Cotton Dyeing & Finishing Mills Ltd

10 No. Habirbari PO, Seed Store Bazzar Thana, Valuka, Mymensing, Dhaka
(+24.315N, 90.38389E)

10 May 2014

Observations Garments Building

Incomplete bracing and inconsistent restraint detail to steel rafter

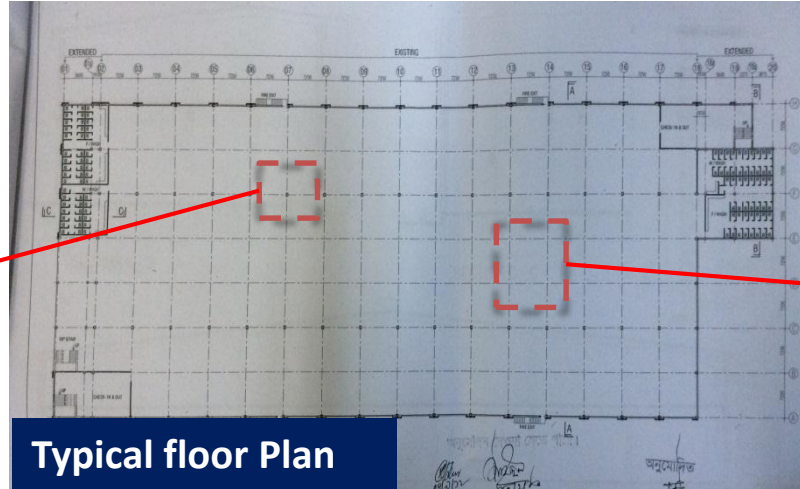
Compression flange restraints for roof rafter steel are provided at a limited number of locations.

Roof horizontal bracing for lateral stability of steel roof structure is incomplete. Building Engineer to review horizontal and vertical bracing.

Structural steel columns do not correspond with sizes shown on building section drawing. Building Engineer to review adequacy of steel roof structure.

Building Engineer to review and confirm that these are provided in accordance with the design.

- The design of the steel roof should be checked by the Building Engineer and, if required, upgraded to support code vertical and wind loads. Specifically the provision of roof bracing (horizontal and vertical) and compression flange restraints should be reviewed.

Cracking of Building Façade

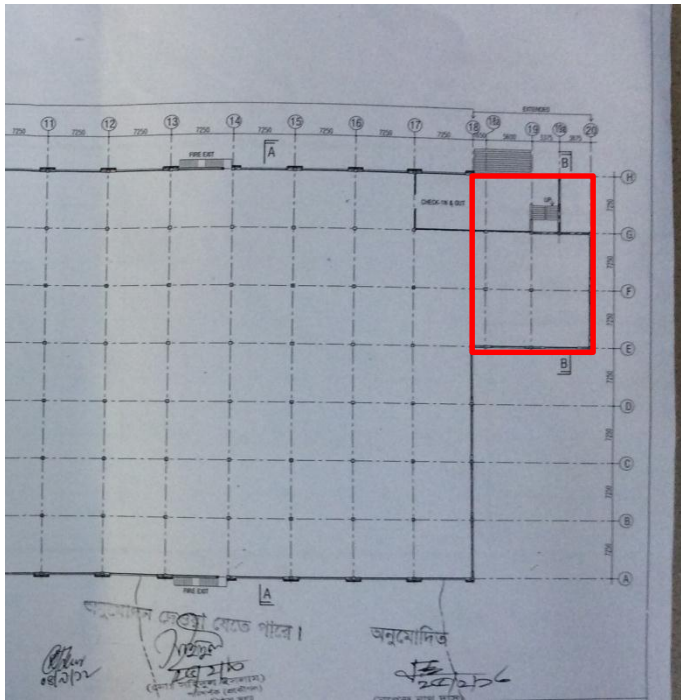
Façade cracks visible on elevations of the Garments Building.

Building Engineer to conduct routine inspection and issue maintenance schedule for façade brick walls

- Building Engineer to inspect area where cracking has occurred and propose a suitable repair to ensure that rainwater does not penetrate the building fabric.
- Building Engineer to provide a method statement for the on-going maintenance of the external facades.

Missing drawings and discrepancies between drawings provided and the as constructed building

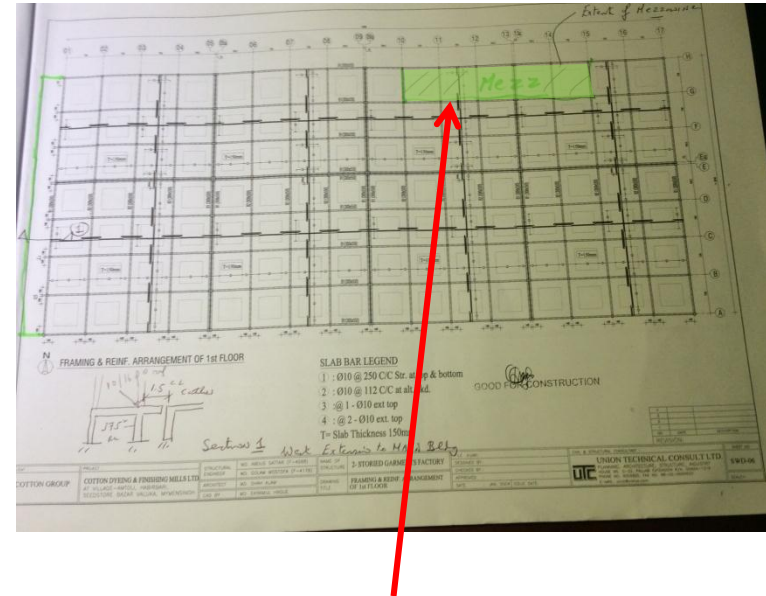
As constructed Eastern extension is rectangular on plan – this differs to layout shown on drawing

Missing drawings for the Mezzanine floor of the Garments Building

Building Engineer to check all drawings and update to match as constructed building.

- Building Engineer to survey as constructed building. Updated drawings to be prepared showing the correct as constructed layout including the steel frame structure.
- Update controlled loading plans for all floors designating allowable storage density and where storage may be placed.

Drawing Discrepancies

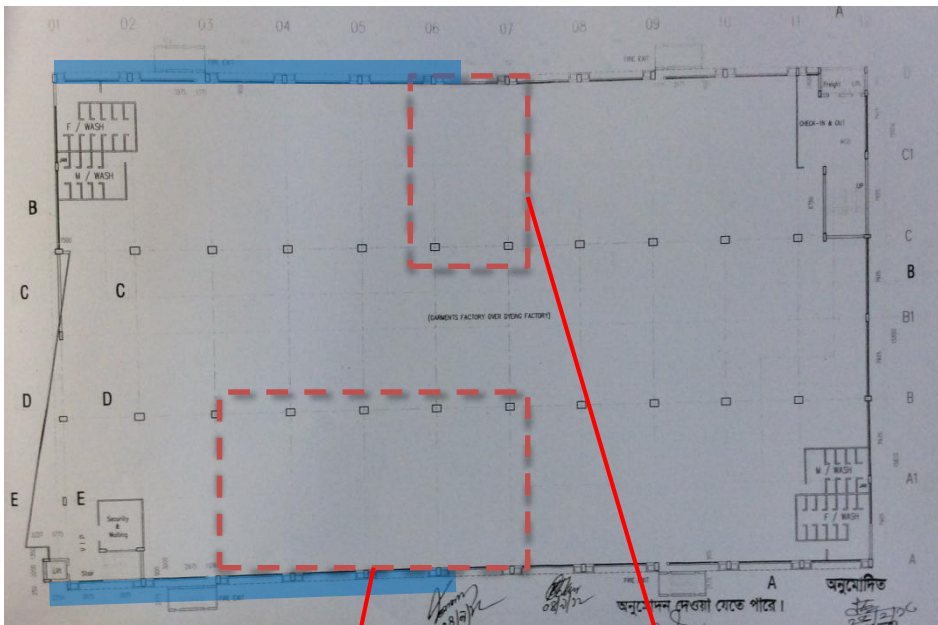
Detailed structural steel drawings for steel roof and columns not provided.

Cracking of floor finishes/slab and management of floor loads

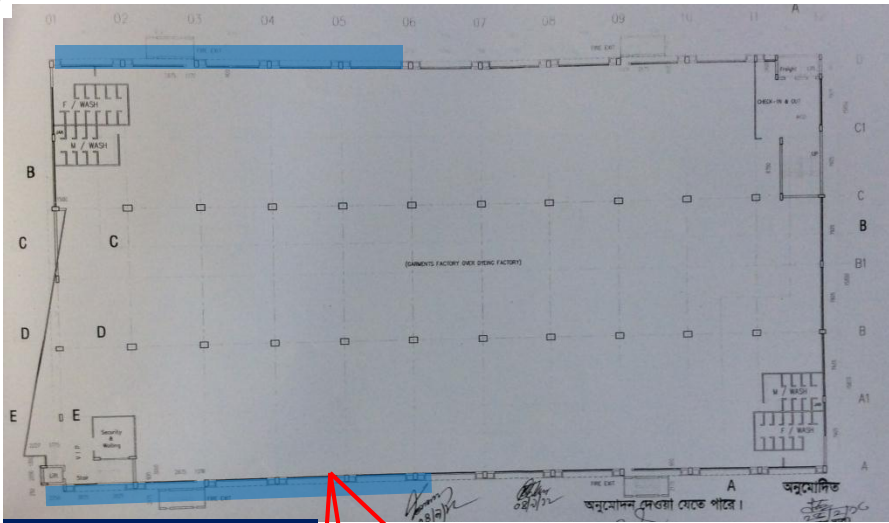
Water tanks loads

Equipment loads

Building Engineer to prepare controlled loading plans, based on floor slab and column capacity, for all floors which will designate allowable storage density and where storage may be placed. Crack repairs to be carried out as necessary.

- Produce and actively manage a loading plan for all floor plates within the factory giving consideration to floor capacity and column capacity.
- Building Engineer to review typical floor finish cracks and confirm that cracking is in finishes only. Where required, remedial works to be carried out.

Cracking of external cantilever slab and building façade

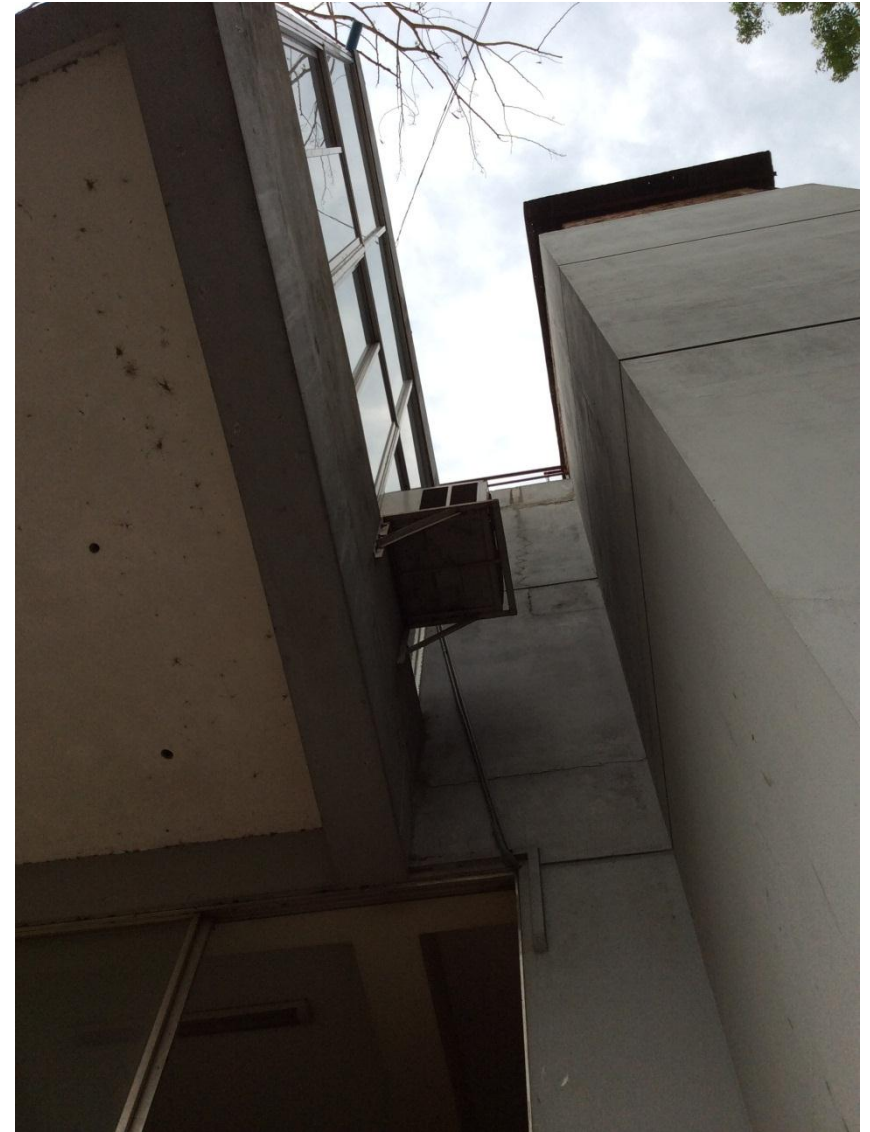
Cracks on the lower level cantilever

Cracks on the upper and lower cantilevers propagating from the column towards the tip of the cantilevers

Façade cracks visible on elevations of the Knitting and Dyeing building.

Building Engineer to investigate reasons for cracking and implement repairs as necessary

Building Engineer to conduct routine inspection and issue maintenance schedule for façade brick walls

- Building Engineer to inspect area where cracking has occurred and propose a suitable repair to ensure that rainwater does not penetrate the building fabric and cantilever slab.
- Building Engineer to provide a method statement for the on-going maintenance of the external facades.

Discrepancies between drawings provided and the as constructed building

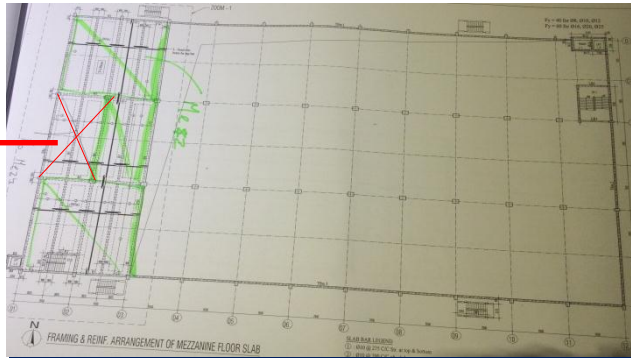
Mezzanine is shown covering 2 full bays at the west end of the building on the RC drawing. As constructed it only covers 1 bay at the middle section of the mezzanine.

- Building Engineer to survey as constructed building. Updated drawings to be prepared showing the correct as constructed layout.
- Update controlled loading plans for all floors designating allowable storage density and where storage may be placed.

Discrepancies between the drawings and as constructed

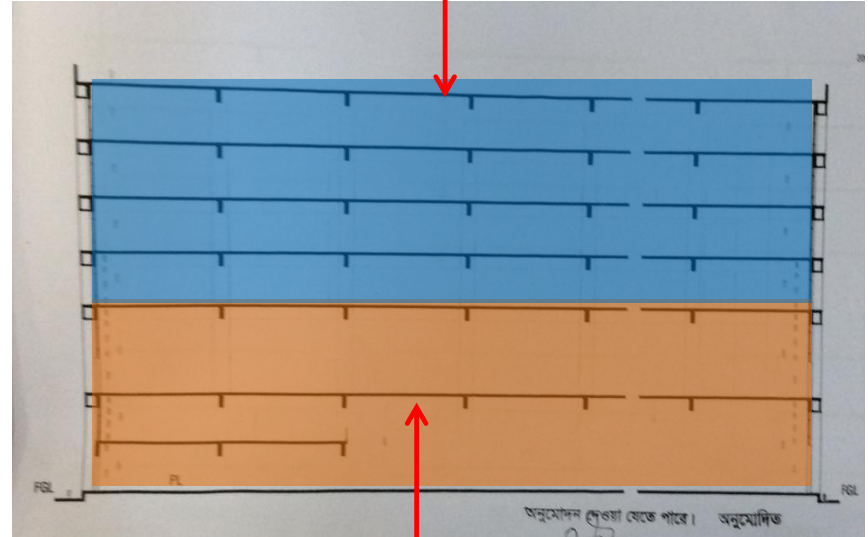
Cantilever slabs as constructed – not shown on drawings

Building Engineer to check all drawings and update as constructed.
